## **Bulletin 2025.1** **Guidance on Recent Parker Velcon** **Product Safety Awareness Bulletins** **July 8, 2025**

## Product Safety Awareness Bulletin – First Notice

**Subject: Gaskets on Fuel Filter Elements** (Open Ended Coalescers, Separators, and various other Fuel Elements)

## Product Safety Awareness Bulletin – Second Notice

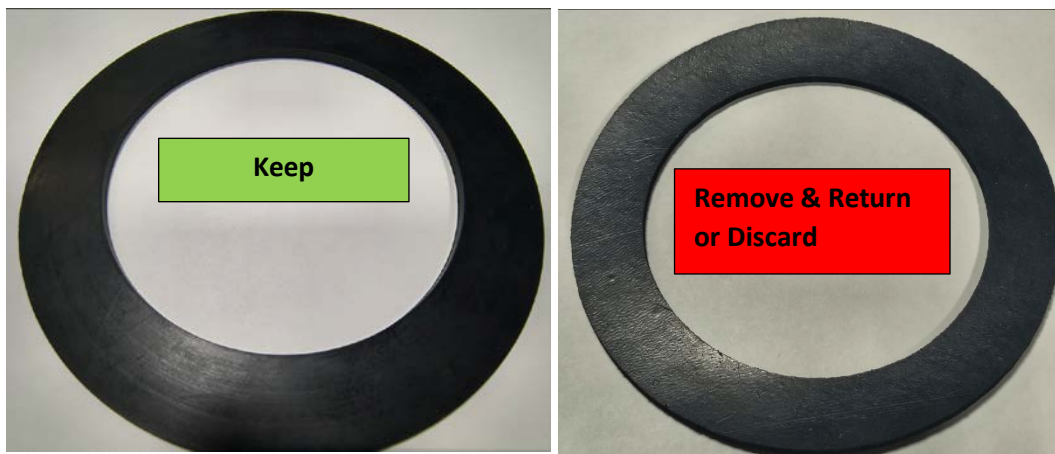
The picture below is an example of the distortion reported on June 18, 2025.

**Inspect your inventory for effected Elements:** If any elements are within the manufactured dates of January 1, 2025, and June 20, 2025, inspect them and DO NOT SHIP any elements that have the gasket considered “Remove & Return or Discard” in the below picture. If the element has the gasket considered “Keep” in the picture below, those elements can be used with no concern of distortion. The two gaskets can be visually inspected to determine which ones can be used and which ones should not be used. The “Keep” gaskets will have a smooth surface finish and sharp cut edges on the Outer and Inner Diameters. The “Remove & Return or Discard” gaskets will have a rough surface texture like leather. The edges are not as sharp but appear to be slightly jagged. Please contact Parker Velcon as soon as possible for assistance. Replacement elements filters will be provided for all elements with the effected gaskets. We are still gathering information and will continue to investigate to provide a more detailed notice and instructions as soon as we can.

**Additional Pictures of gaskets showing visual differences:**

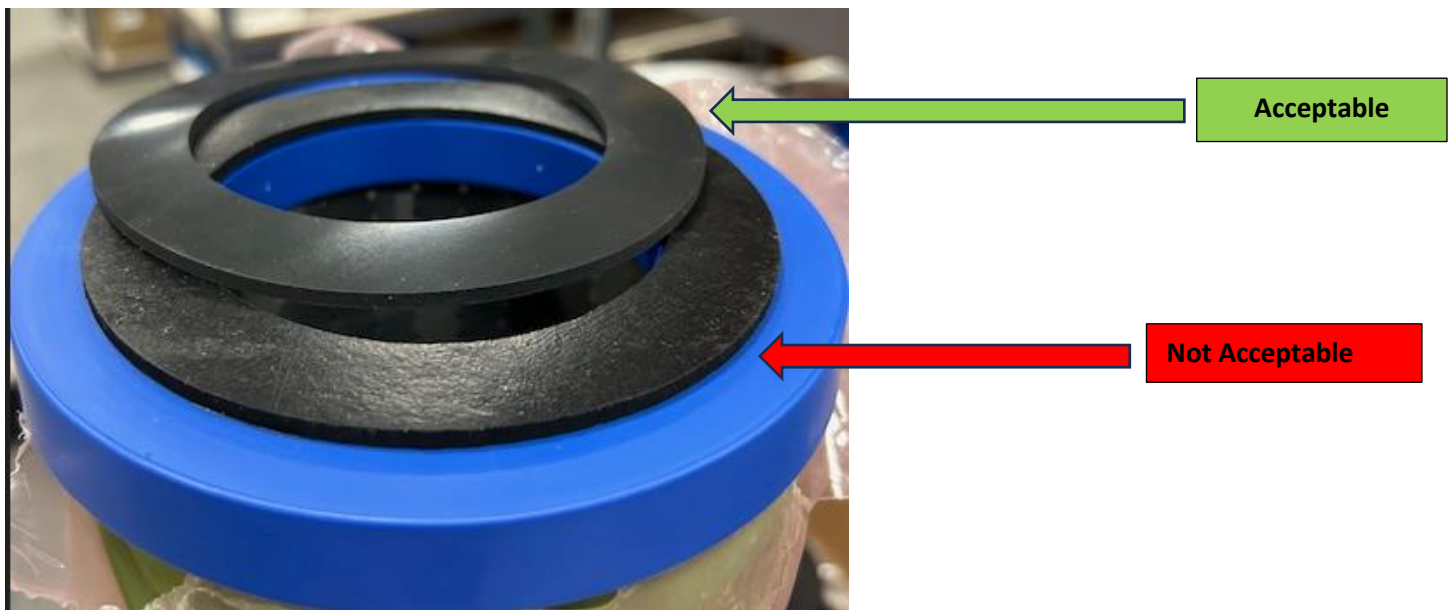
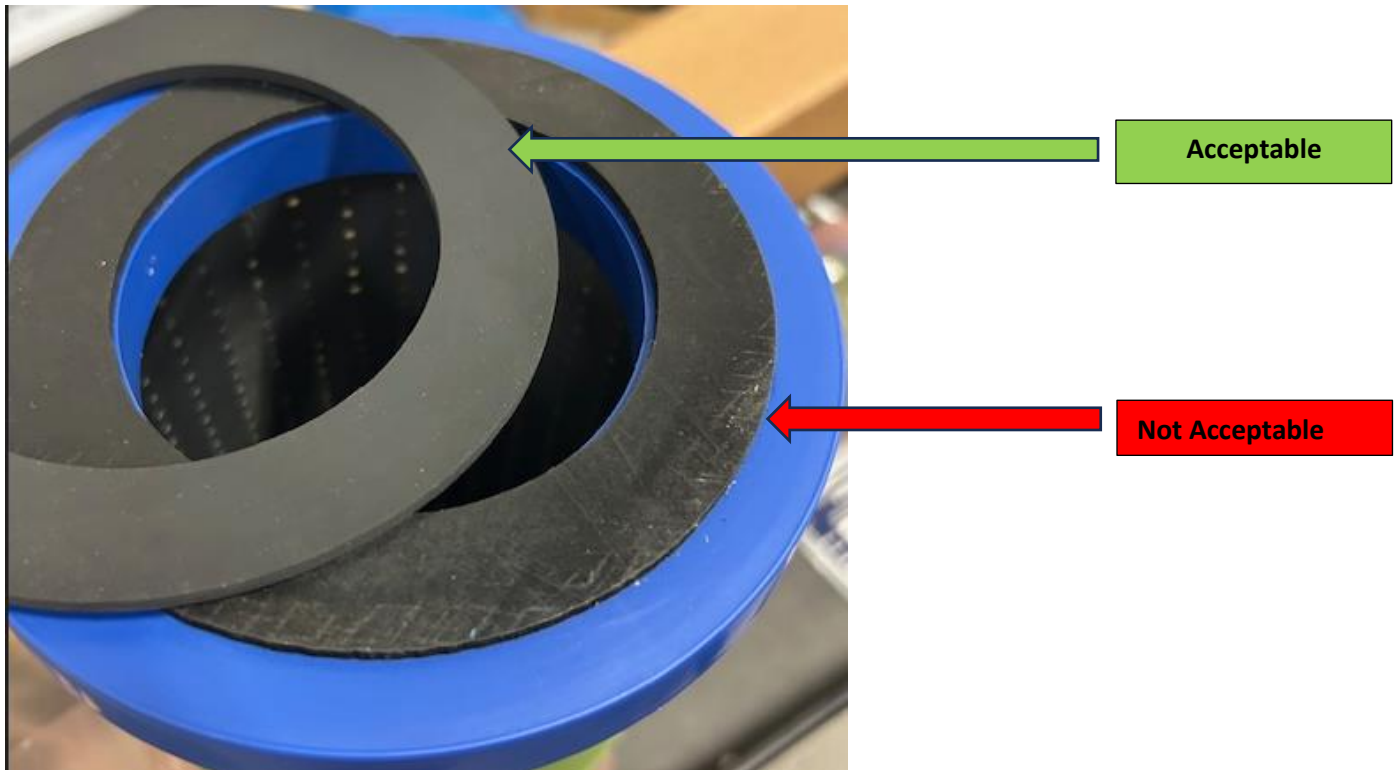
The picture below is an example of the distortion that was reported on June 18, 2025.

2. **Inspect your inventory for effected Elements:** If any elements are within the manufactured dates of January 1, 2025, and June 20, 2025, inspect them and DO NOT SHIP any elements that have the gasket similar to the gasket labeled “Not Acceptable” in the below picture. If instead the element has the gasket similar to “Acceptable” in the picture below, it may be used with no concern of distortion. The two gaskets can be visually inspected to determine which can be used and which should be quarantined. The “Acceptable” gaskets will have a smooth surface finish and sharp cut edges on the Outer and Inner Diameters. The “Not Acceptable” gaskets will have a rough surface texture, similar to leather. The edges are not as sharp but appear to be slightly jagged. Please contact Parker Velcon as soon as possible for assistance. Replacement filter elements or rework will be provided for all elements with the affected gaskets.

- c) Dry the gasket with a clean cloth to allow for a better visual of the gasket.
      - d) Determine if the gasket is acceptable or if non-acceptable as illustrated in the pictures above.

- e) Elements with non-acceptable gaskets are required to be replaced.
      - f) Elements with gaskets that cannot be confirmed as acceptable should also be replaced.
